RE: 35R Lexington Ave SPSR - UPDATE SINCE NOV 4 MEETING

Case #: ZBA 2009-45

PLANNING STAFF REPORT

Site: 35R Lexington Avenue

Image of the massing that would be allowed by-right on the site (building footprints – left, looking north and south – below)

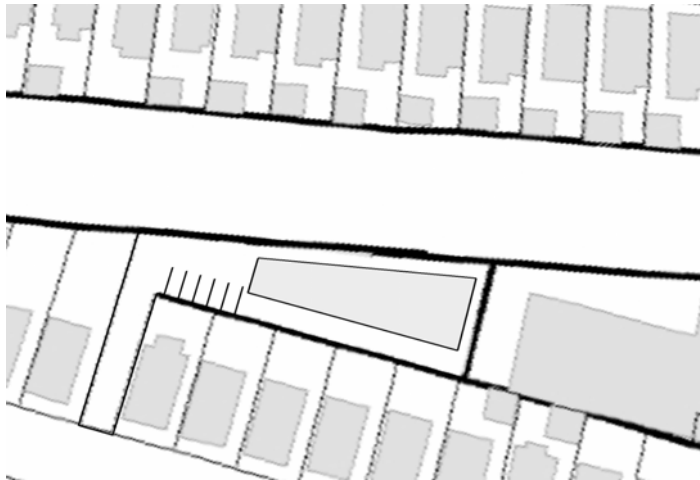
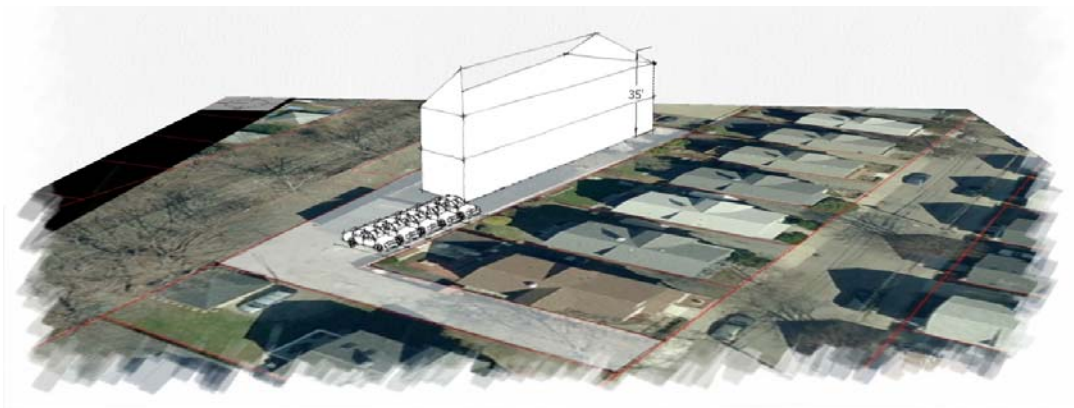
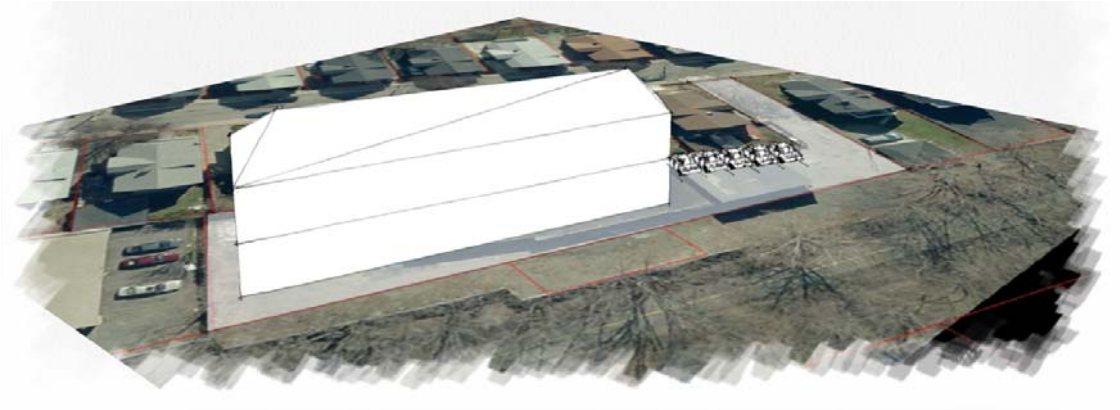
Under the current zoning, the developer could build two attached units on the site, but Planning Staff believe such development could be larger, bulkier, more detrimental to the neighborhood and could present a far less appealing appearance along the Community Path. The new building would have to conform to the dimensional requirements of the RA zoning district, including a 2.5 story height requirement but could be as much as 11,156 s.f. in size and up to 35 feet in height. If the applicant elected to build a by right project, the only issues to be reviewed would be building permit and public safety issues addressed by the Inspectional Services Division and Fire Department. There would be no ZBA public hearing, and no direct neighborhood input. Planning staff developed an image that shows the basics of the bulk of what could possibly be built by-right (image below).
